LAND AT PALK ROAD

FLOOD RISK ASSESSMENT & DRAINAGE STRATEGY

REPORT REF NO. 2108040-01B
PROJECT NO. 2108040
FEBRUARY 2024

RESPONSE TO CONSULTEE COMMENTS – Land at Palk Road, Havant (REF: APP/22/01231)

FOUL AND SURFACE WATER DRAINAGE STRATEGY

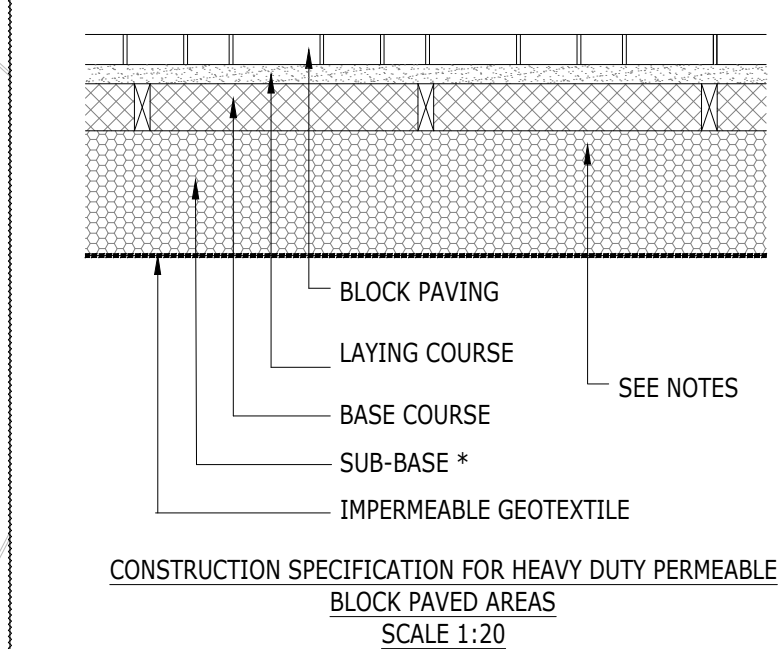
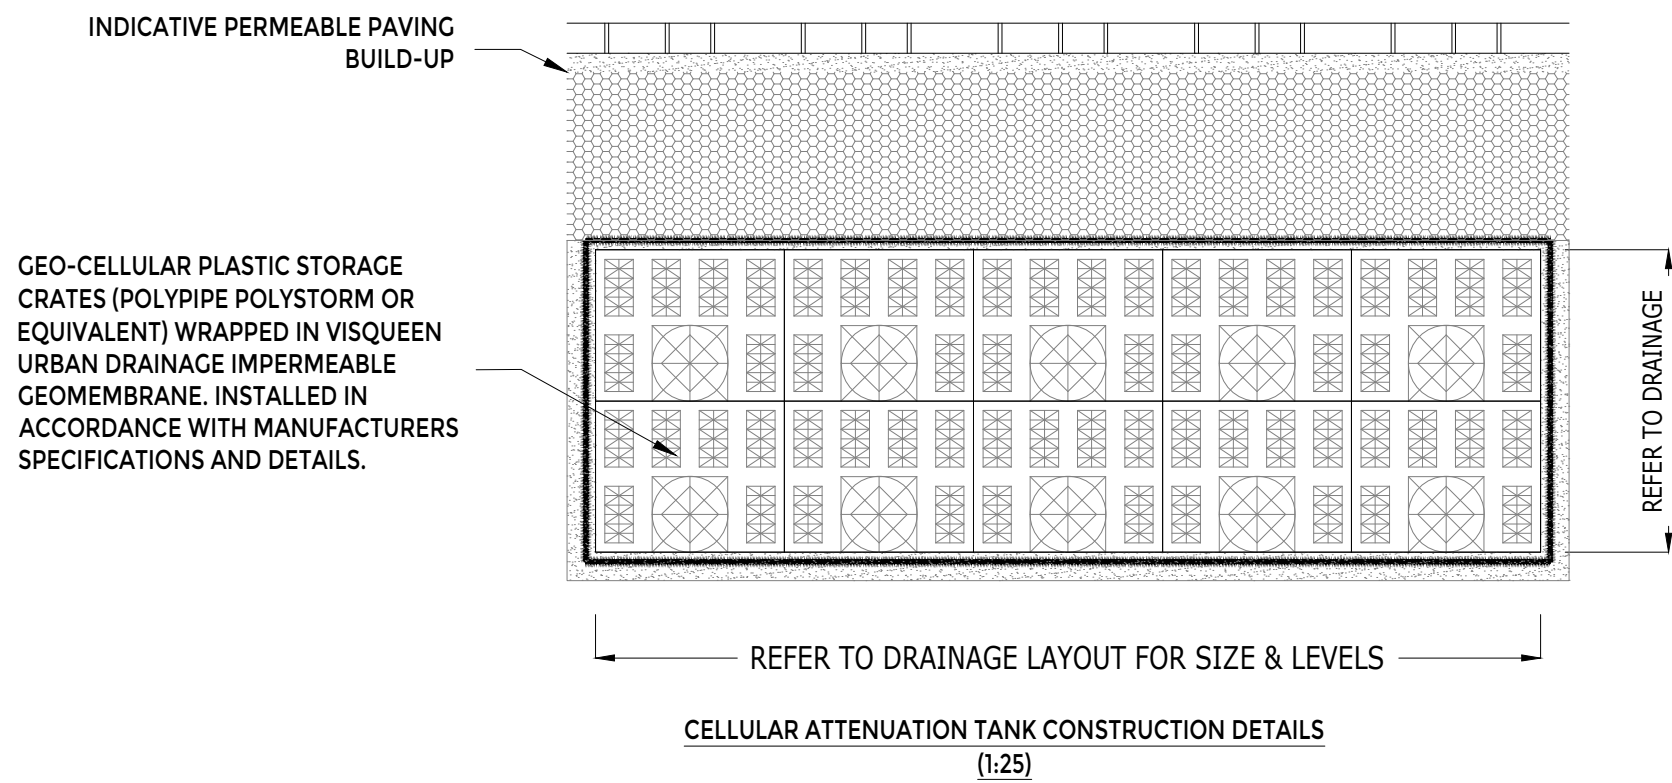
Calculations have been provided for the storage and network, showing very minor flooding at the 1 in 100 year event. Climate change allowances have not been applied to the 1 in 30 year event, this is required to determine whether any flooding occurs in the network for this event. Flood exceedance flow routes have been shown on the layout.

- Confirmation that floor levels for development in the low surface water flood risk area will be above modelled flood levels (this is in addition to the modelled Flood Zone area that considers climate change).
- Confirmation of whether there is an existing connection to the surface water sewer or whether approval has been sought from the water

The indicative extents of the minor flooding in the 1 in 100 year, including climate change, event have been included on the drainage strategy drawing (2108040-001D).

As stated in the FRA produced by Ardent (Ref. 2108040-01A), the surface water flood extents shown on site are largely associated with the Hermitage Stream. Flooding extents are shown on the Foul and Surface Water Drainage Strategy Drawing (Ref. 218040-001A). This shows the extents to be confined mostly to the southwest of the site and outside the extent of all residential and commercial development and is therefore of negligible significance.

Exceedance flow routes are identified on the Foul and Surface Water Drainage Strategy Drawing (Ref. 218040-001B), indicating flows will drain towards the highway network and subsequently flow towards the Hermitage Stream beyond the site's southern boundary.
